FREDERICK COUNTY PLANNING COMMISSION

TITLE: Ramsburg Preliminary Subdivision Plan

FILE NUMBER: S-933, (AP #13629, APFO #13630 & FRO #13631)

REQUEST: Preliminary Plan Approval

Graphic #1: Site Aerial

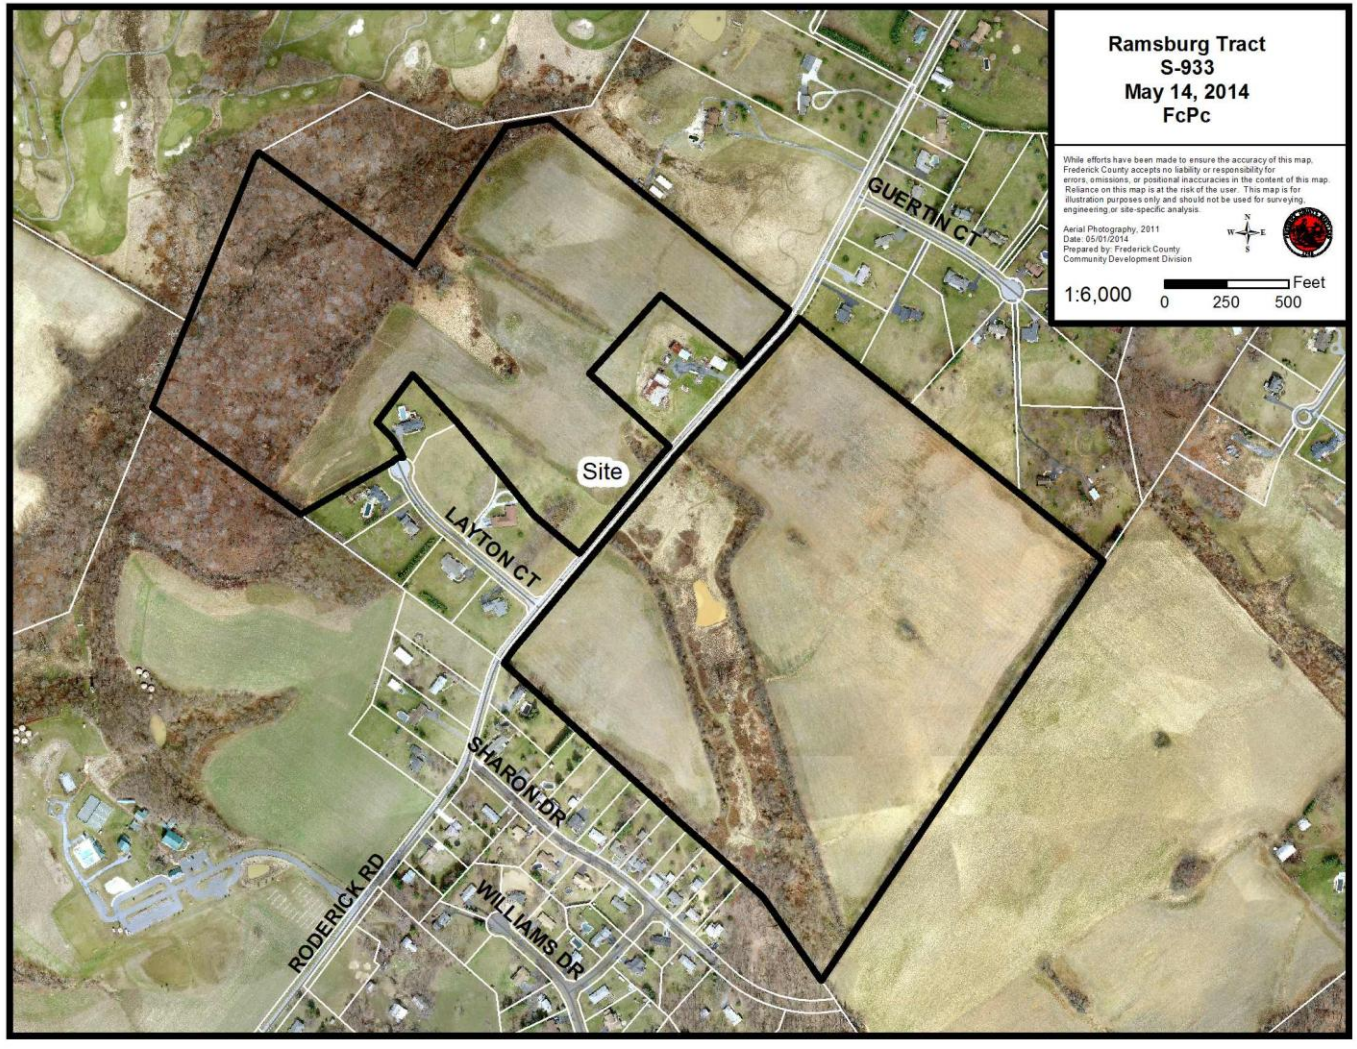
The project is comprised of two portions located on either side of Roderick Road. The eastern portion of the project proposes 34 single family lots and the western portion of the project proposes 23 lots. The site is zoned R1 residential and is surrounded by primarily large lot residential development on the north and south, existing cropland on the east, and the Worthington Manor Golf Course on the west. Areas of forest were identified on both sides of Roderick Road and were associated with forested corridors that extended off site along North Branch on the west and an unnamed tributary of Bennett Creek on the east. A total of 3.83 acres of existing forest was identified on the east side of Roderick Road and 19.24 acres of existing forest is located on the west side for a combined total of 23.07 acres. All of the existing forested areas within the sensitive areas must be retained. See Graphic #1.

Graphic #2: Zoning Map

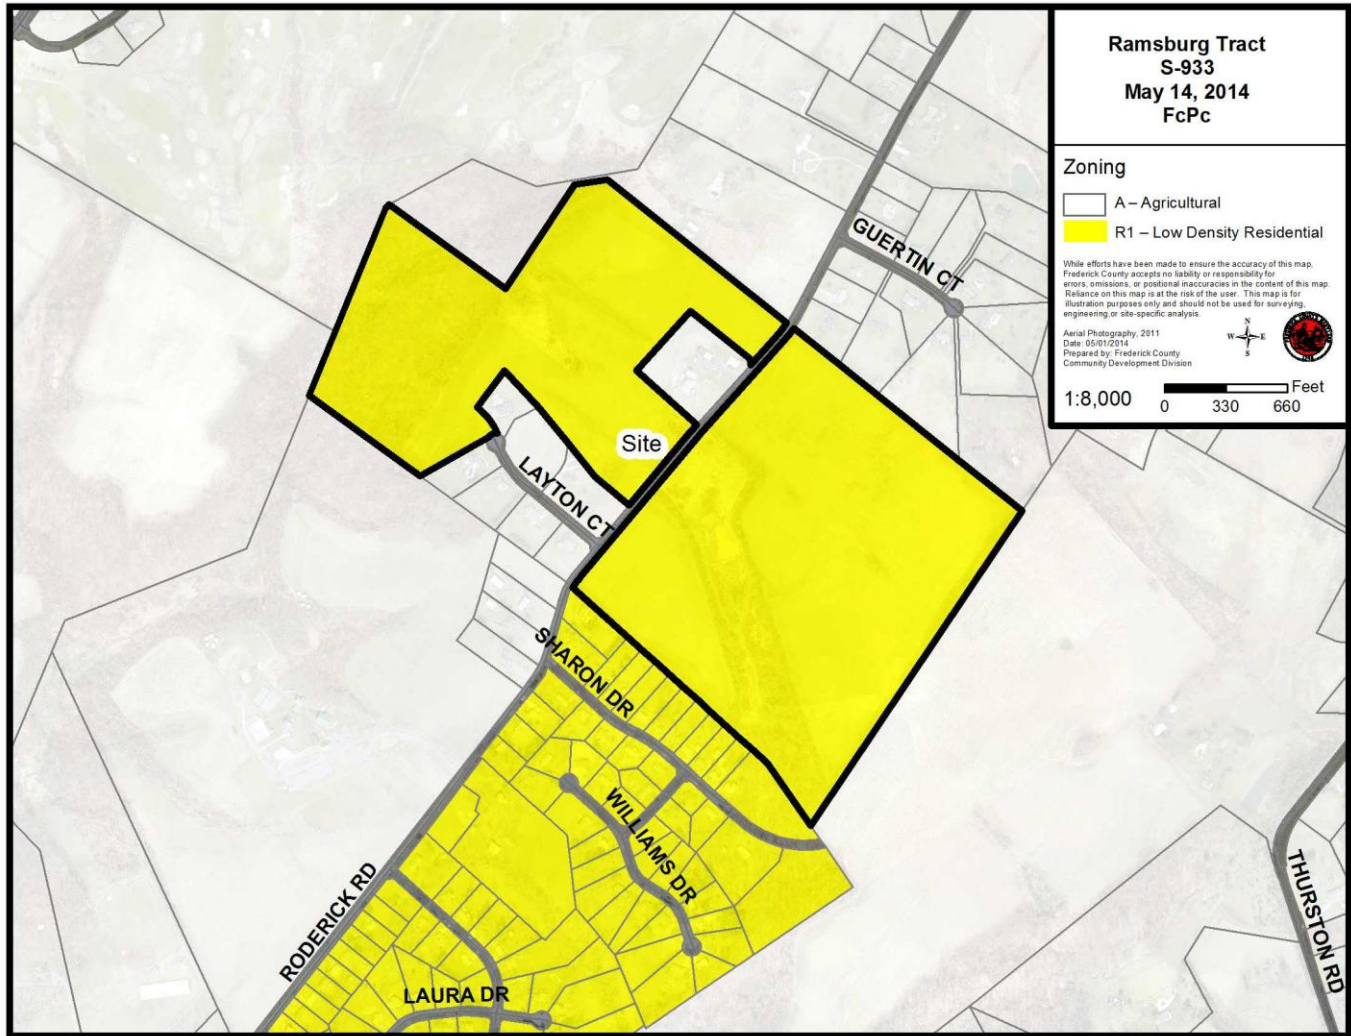
The subject property has a comprehensive plan designation of Rural Residential and is intended for low density residential development. The proposed land use and subdivision design complies with the Comprehensive Plan and meets Zoning Ordinance requirements for the R-1 Zoning District. See Graphic #2.

The proposed development is located on property zoned R-1 residential See Graphic #2. As provided in Section 1-19-6.100 of the Zoning Ordinance, the minimum design requirements in the R-1 residential zoning district are: 40,000 square foot minimum lot size, 100 foot minimum lot width, 40 foot front setback, 30 foot rear yard setback, and 10 foot side yard setback, 30 foot maximum structure height for single family residential development. .
